CITY OF TUCKER

ITB #2026-001

ROSENFELD PARK IMPROVEMENTS CONSTRUCTION

ITB #2026-001
ADDENDUM #1

TERRACED SEATING - SECTION CUT (A - A')

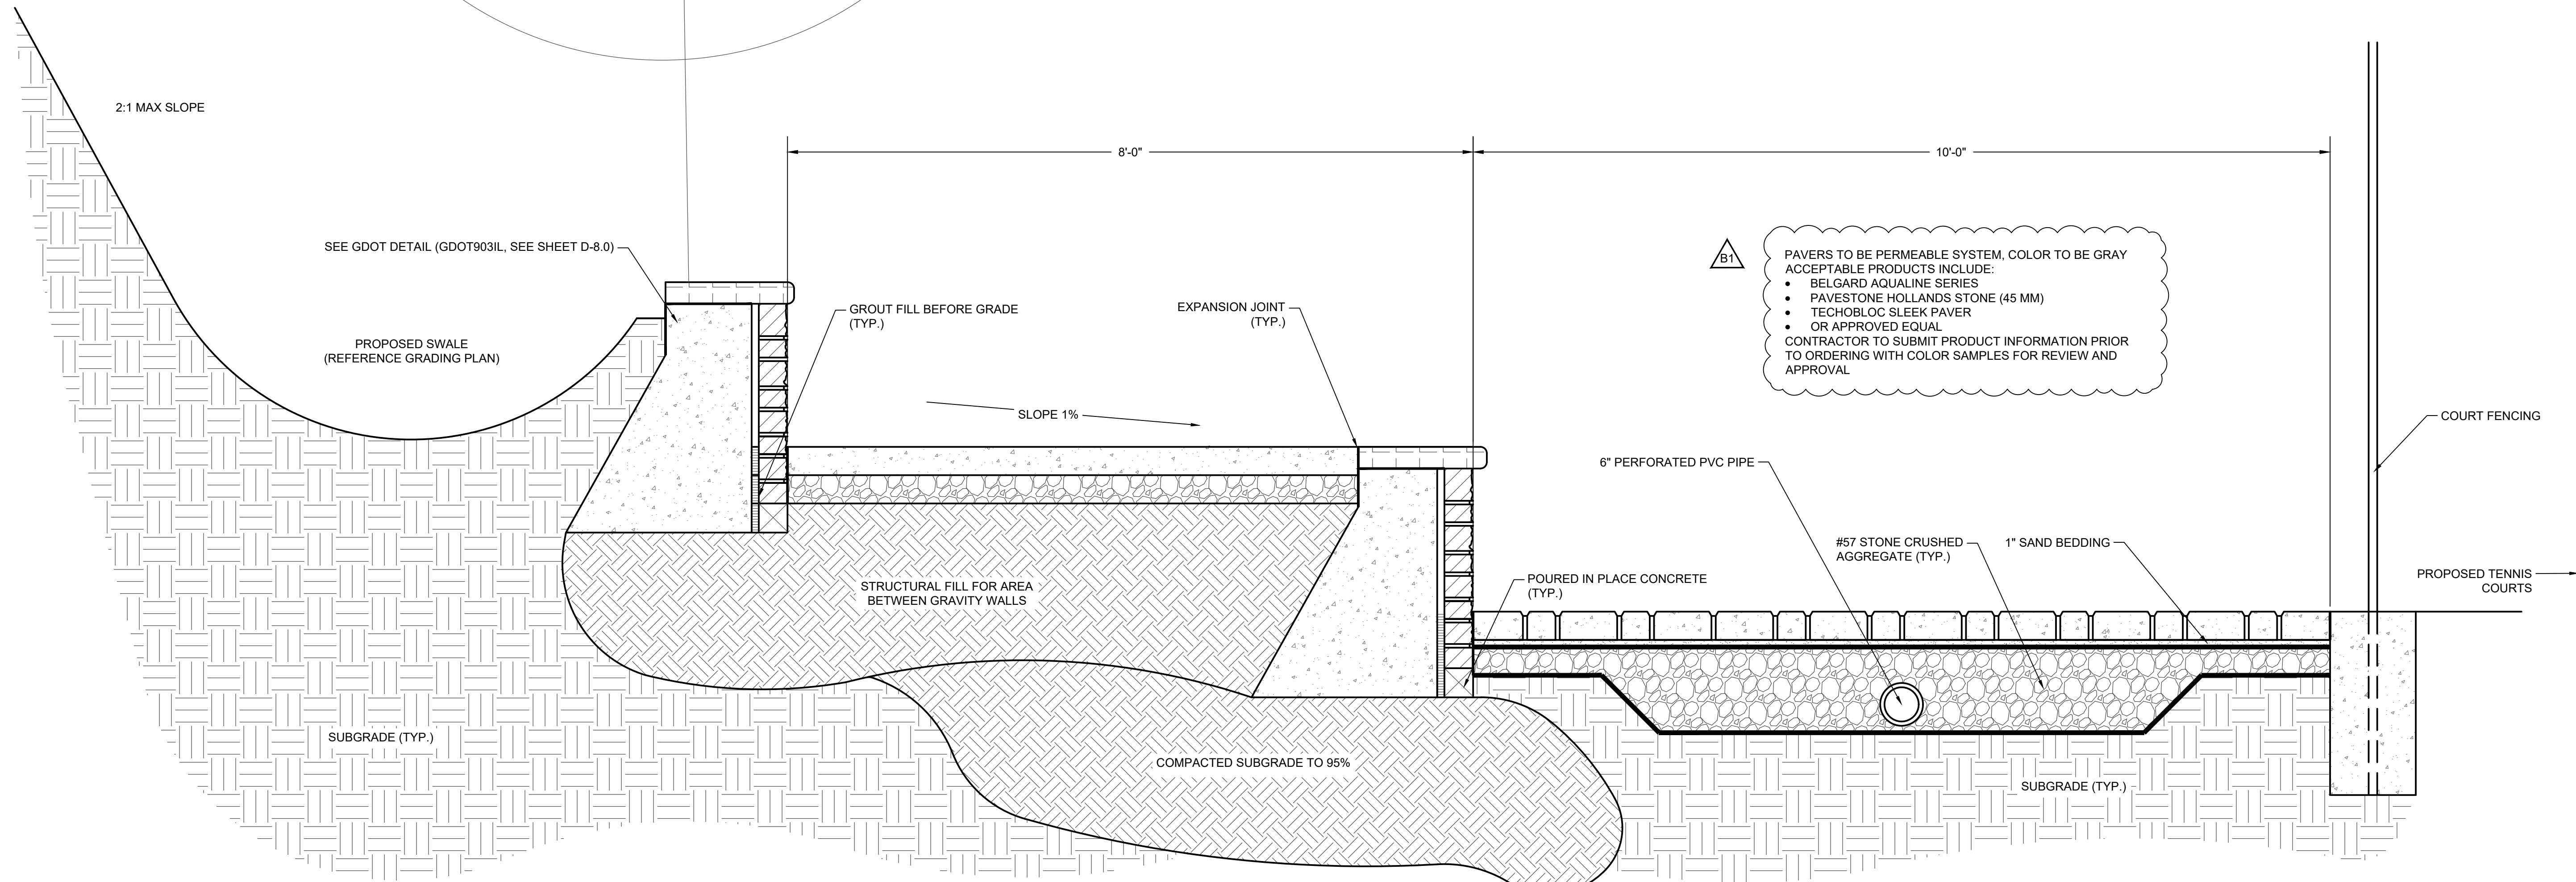
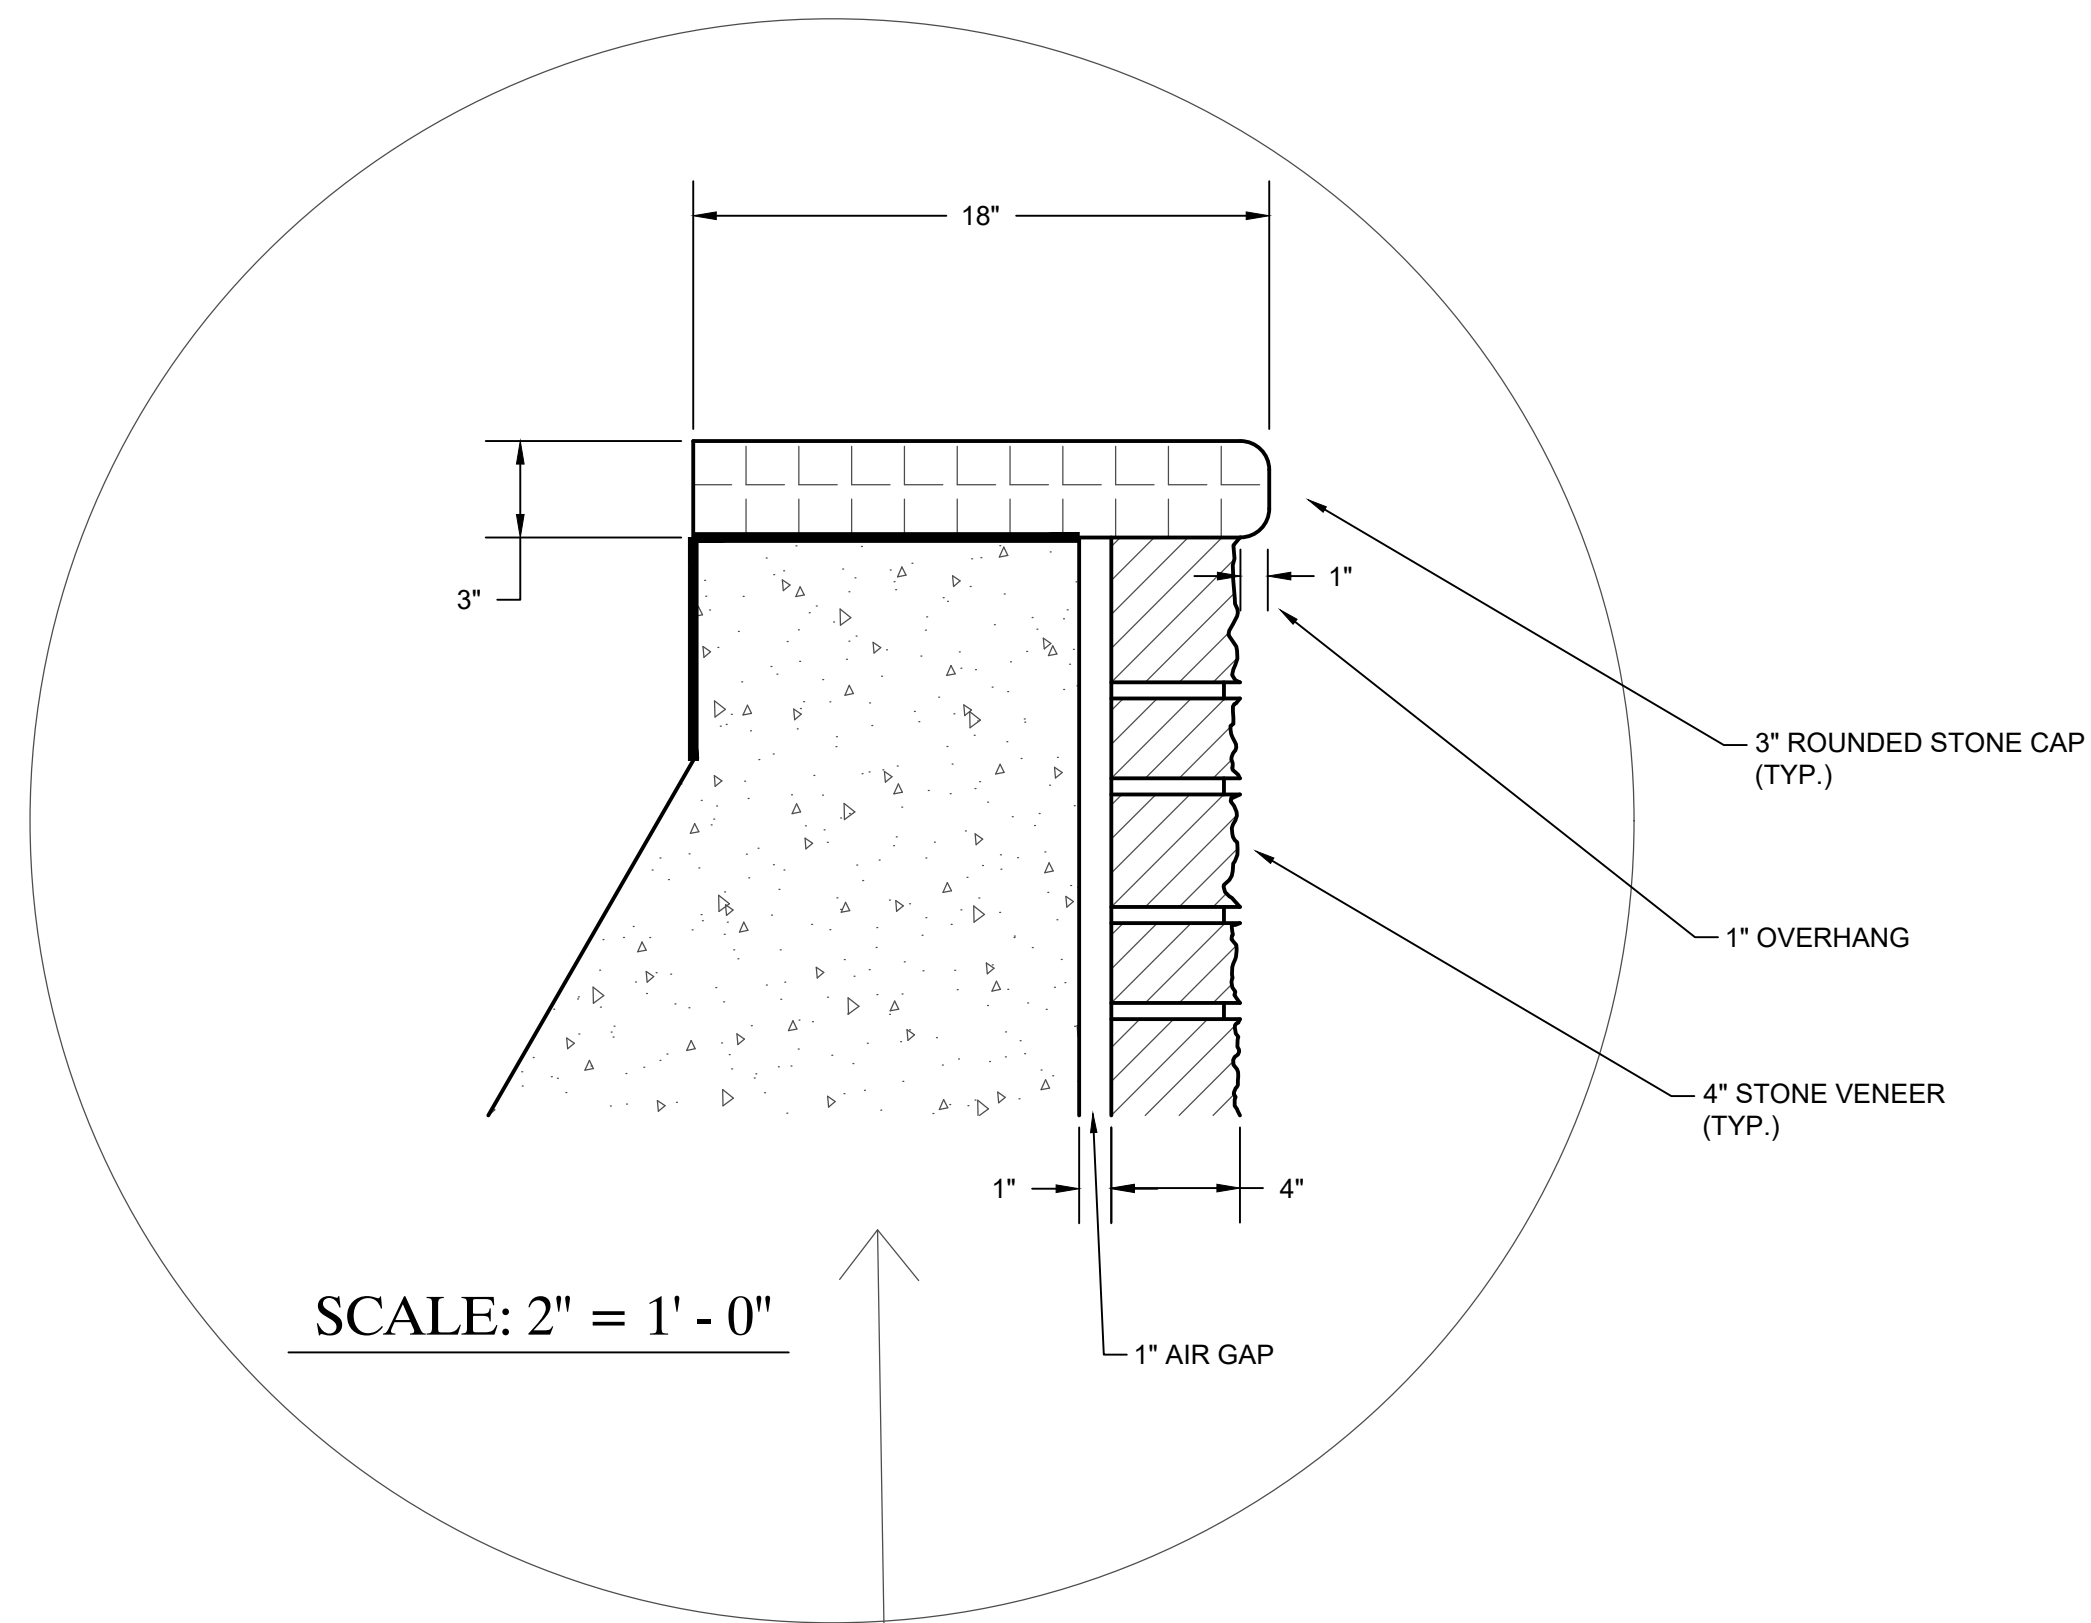
| | QUESTION | ANSWER |
|----|--|---|
| 8 | Please clarify the type of stone, pattern, and cap on the terraced seating wall (Reference D7.0) | The wall shall have a Elberton Granite Stone Veneer installed in an Ashlar pattern. The cap shall also be Elberton Granite Stone with a smooth top. |
| 10 | Please confirm the paver material between the terraced seating and courts (Reference D7.0) | Pavers to be installed as shown on the section detail on Sheet D-7.0. Revision included in this addendum. Pavers shall be decorative precast concrete equal of Pave-Stone. Material and pattern to be selected by the City. |

| 32 | Please provide the brick paver details. | Pavers to be installed as shown on the section detail on Sheet D-7.0. Revision included in this addendum. Pavers shall be decorative precast concrete equal of Pave-Stone. Material and pattern to be selected by the City. |
